Subject: Exhaust Discharge Location

Models Affected: Specific Freightliner Business Class M2 and Cascadia vehicles manufactured June 2, 2011, through October 29, 2014, and equipped with CNG fuel tanks.

February 2015
FL671A-G
NHTSA #14V-680
Transport Canada #14-547

Fig. 1, Exhaust Pipe Installation, Two Hangers

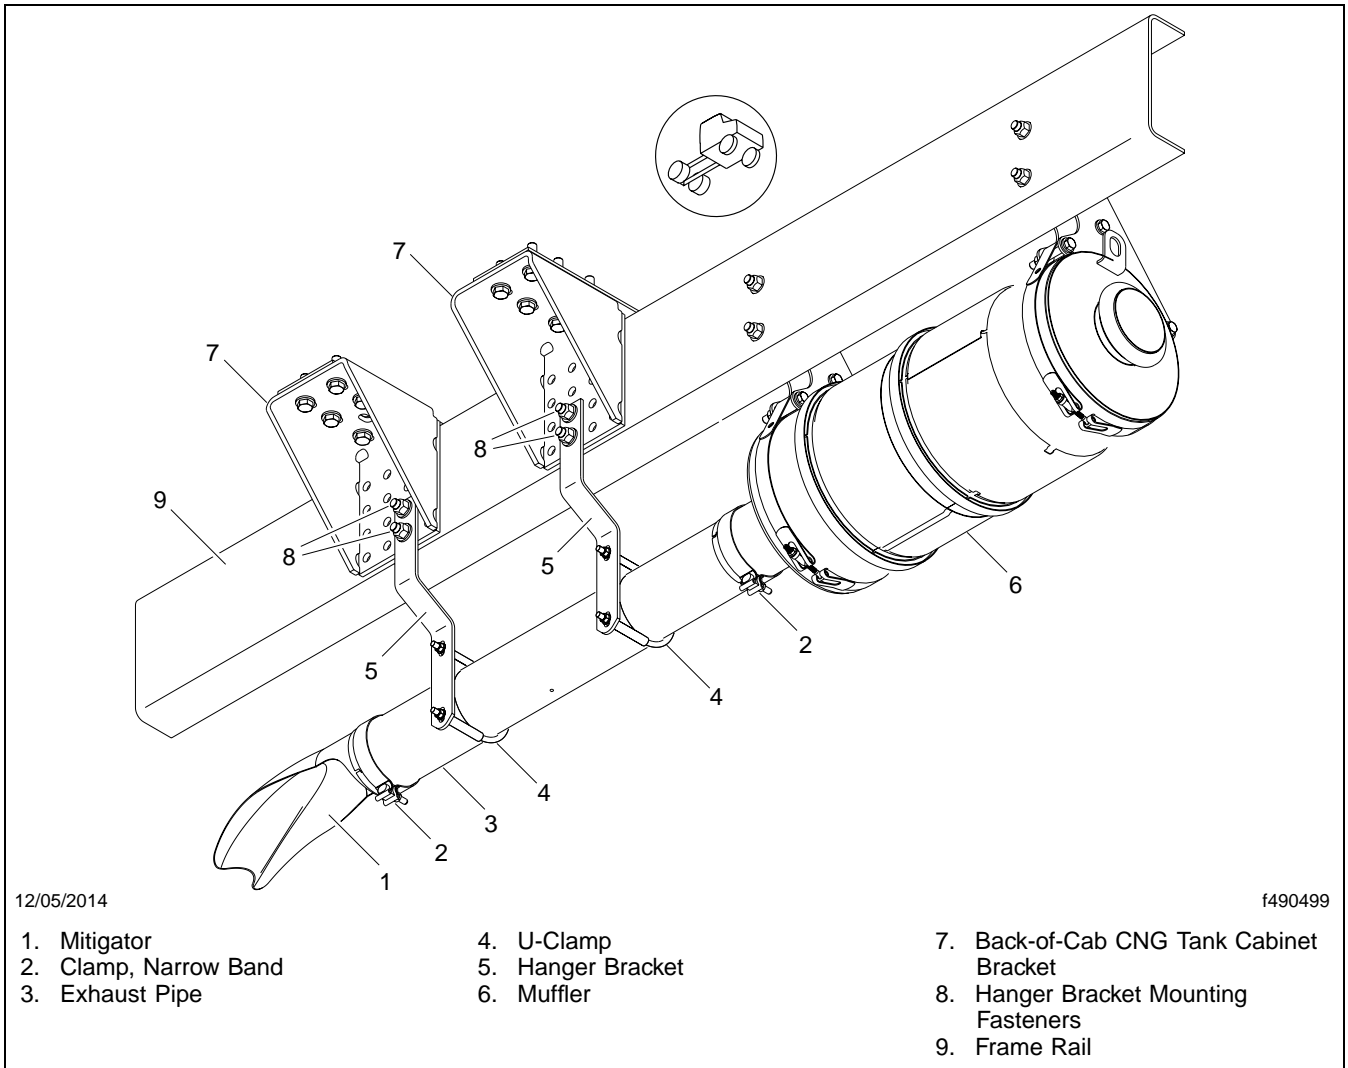
3. Remove the existing exhaust pipe and mitigator. Save the mitigator for reinstallation. Discard the clamps and pipe.
4. Vehicles in FL671A-C require two hanger brackets. Refer to **Fig. 1** on page 8 for installation, then proceed to step 5 on page 10.

Fig. 2, Exhaust Pipe Installation, One Hanger

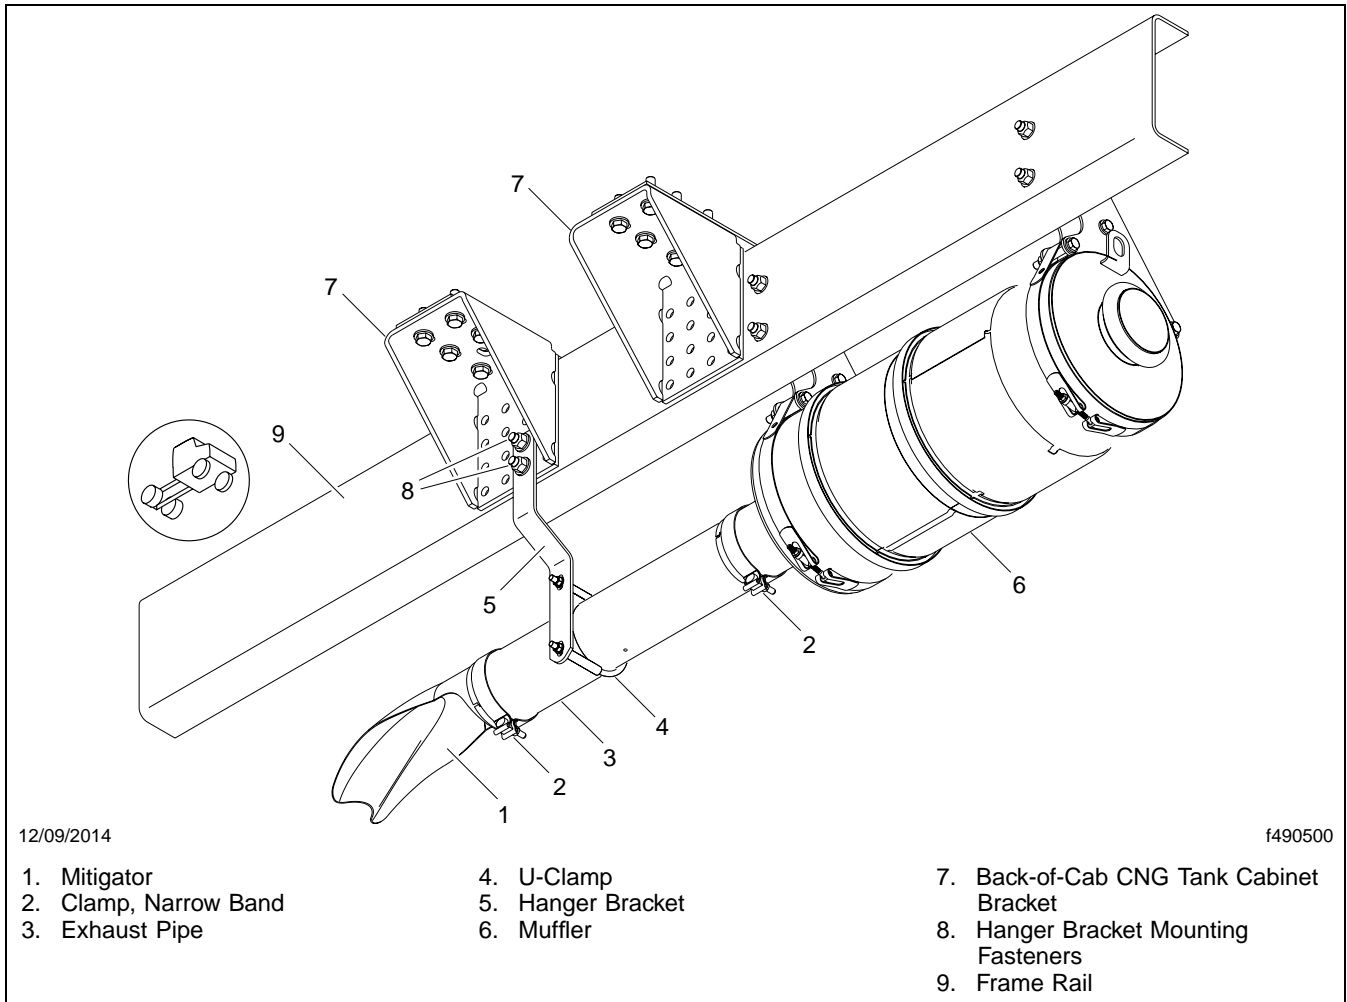
Vehicles in FL671D-F require one hanger bracket. Refer to **Fig. 2** on page 9 for installation, then proceed to step 5 on page 10.

Fig. 3, Exhaust Pipe Installation, No Hangers

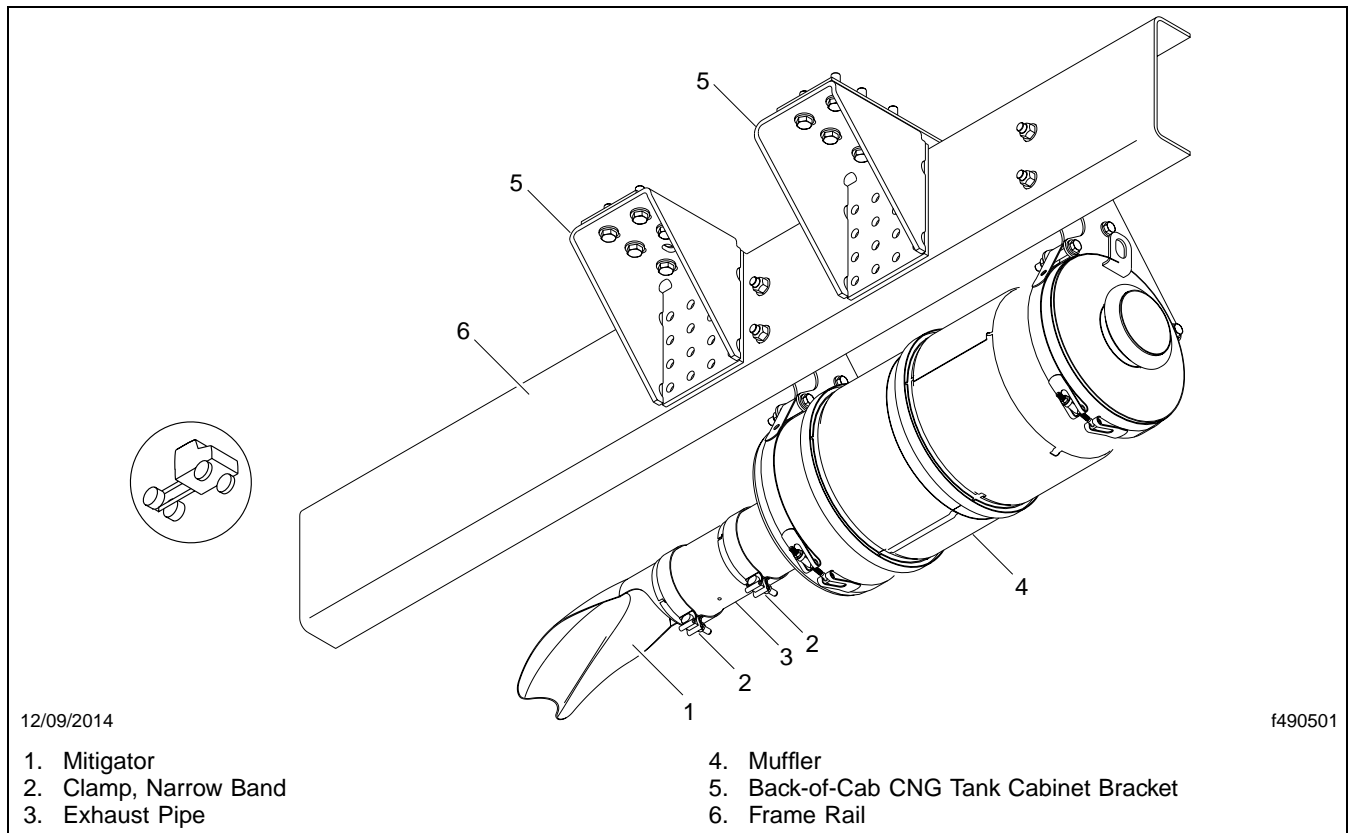
Vehicles in FL671G do not require a hanger bracket. Refer to **Fig. 3** on page 10, then proceed to step 9 on page 11 for installing the tailpipe extension.

Fig. 4, Determining the Hanger Locations

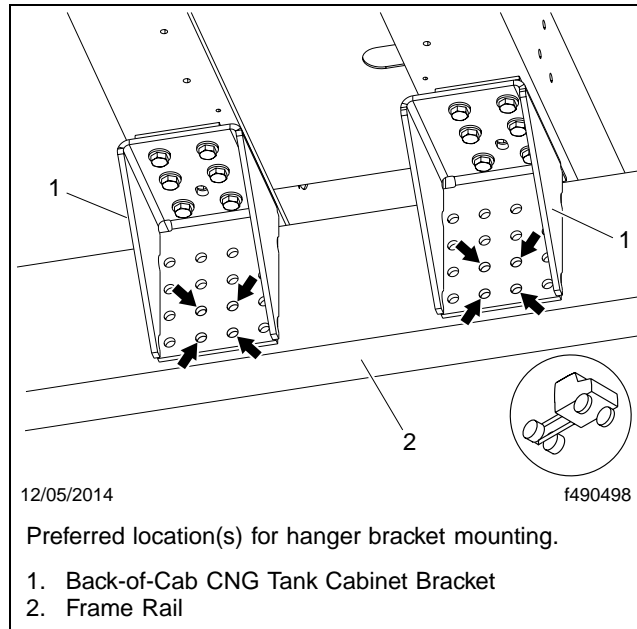
6. Determine the best location for the hanger bracket(s). Where possible, use the existing holes in the back-of-cab tank cabinet mounting bracket(s). See **Fig. 4**.
7. Using the existing holes in the back-of-cab CNG tank cabinet mounting bracket as a guide, drill additional holes in the frame rail as needed to mount the hanger brackets.
8. Install the required hanger bracket(s) using the nuts, bolts, and washers from the hardware kit. Tighten the mounting nuts and bolts 128 lbf-ft (173 N·m).

IMPORTANT: The preferred location for the new hanger bracket(s) is in existing holes in the frame rail. Usually, two of the central lower holes used to mount the back-of-cab CNG tank cabinet mounting bracket will work best. Choose the hole locations with the best access from both sides of the frame rail. If needed, additional holes must be drilled. If drilling holes anywhere else, follow the "Drilling Holes" guidelines in **Subject 31.00, 100** of the *Cascadia Workshop Manual*.
